AGENDA
PLANNING AND PUBLIC WORKS COMMITTEE
MEETING

RE: **P.Z. 09-2024 14001 Olive Blvd. (BluOnx Development LLC):** A request for an ordinance amendment to the existing “PUD” Planned Unit District to new “PUD” Planned Unit District for a 29.4-acre parcel located on the north side of Olive Blvd (Ward 1).

Description: **P.Z. 09-2024 14001 Olive Blvd. (BluOnx Development LLC)**: A request for an ordinance amendment to the existing “PUD” Planned Unit District to new “PUD” Planned Unit District for a 29.4-acre parcel located on the north side of Olive Blvd.

Preliminary Development Plan (PDP) Comments:

DRAWN BY: K.S.G.	CHECKED BY: G.M.S.
DATE: 10/02/2024	JOB NO.: 219-6568.3
M.S.D. P.#: —	BASE MAP #: 16R
S.L.C. H&T #: —	H&T S.U.P. #: —
M.D.N.R. #: MORA	
SHEET TITLE: PRELIMINARY DEVELOPMENT PLAN	
SHEET NO.: C1.0

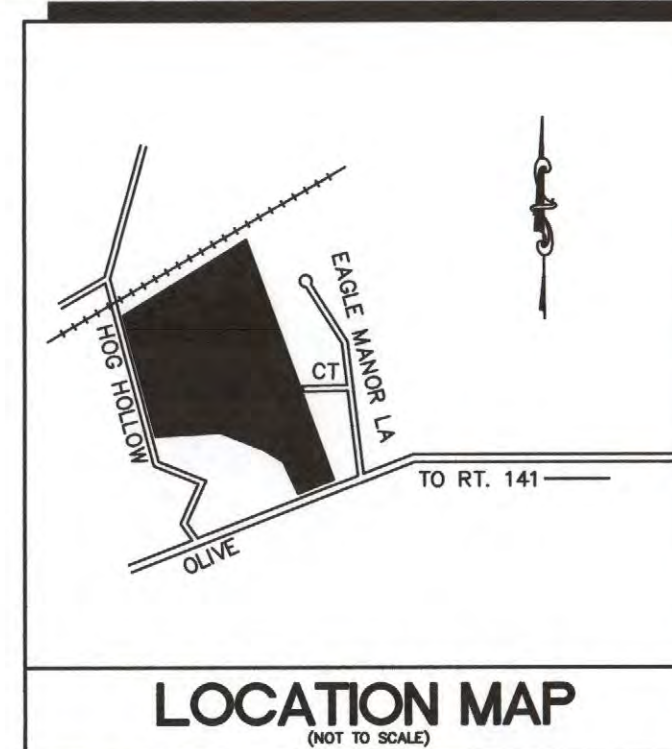
3. Under Common Open Space on Sheet C1.0 of PDP, please remove the ordinance reference 3143, as the PDP is for new ordinance.

5. The single-family attached units show a grey square box at the rear of the building. Please be advised that no structures are allowed in the rear setback. In order to avoid any confusion, please remove the proposed boxes from the sheet C1.0.

9. Revise the "Typical Street Section" to indicate private streets.

10. Plans indicate “Proposed 5’ walk” along Olive Boulevard. MoDOT recently installed a sidewalk along Olive Boulevard. Show the existing sidewalk and remove the note.

11. A sidewalk is missing on the east side of the new street, near the connection to Olive Boulevard. Provide sidewalk on both sides of all streets.

12. If the 8’ path is desired along the roadway as proposed, the building setback for lots where the path is located will need increased to ensure vehicles parked in driveways do not block and/or overhang the path. The space from the back of the proposed sidewalk/multi-use path easement shall be a minimum of 20 feet (5’ easement = 25’ building setback, 9’ easement = 29’ building setback). Please revise the typical lot details and plan.

13. Delete and/or revise General Note 3 to read “Approval of this plan does not constitute approve of slopes in excess of 3:1.” In accordance with City requirements the maximum allowable slope is 3H:1V. Slopes steeper than 3H:1V require review and approval from a geotechnical engineer concurrent with grading/improvement plans.

14. Include conceptual information on the plan for ultimate discharge point for the proposed stormwater management basins and storm sewers. If stormwater is discharged to Hog Hollow Road, storm system improvements will likely be necessary to mitigate potential erosion and/or capacity issues.

15. Eagle Manor Ct. was intended to be extended with future development. Since it will be gated, provide an appropriate turn-around at the end of the public side of Eagle Manor Ct.

Response: Change made as requested.

Response: The Grey square is a 10'x10' concrete slab (patio) on grade. We have revised them to be 10' wide x 8' deep. This places them 5 ft. off the property line leaving a 10 ft. green strip for storm drainage.

Response: Section revised as requested.

Response: Preliminary Development Plan has been revised as requested.

Response: Preliminary Development Plan has been revised as requested.

Response: Preliminary Development Plan has been revised as requested.

Response: Note has been updated as requested.

Response: Storm pipe discharges have been added to the Preliminary Development Plan. The Stormwater Management Basins are designed including channel protection and flood storage specifically to mitigate against creek erosion. The existing culverts are intended to be used in place, but for stone and fabric revetment at the upper and lower ends of the culverts.

Response: The proposed emergency access gate is being slid west to within the development project limit.
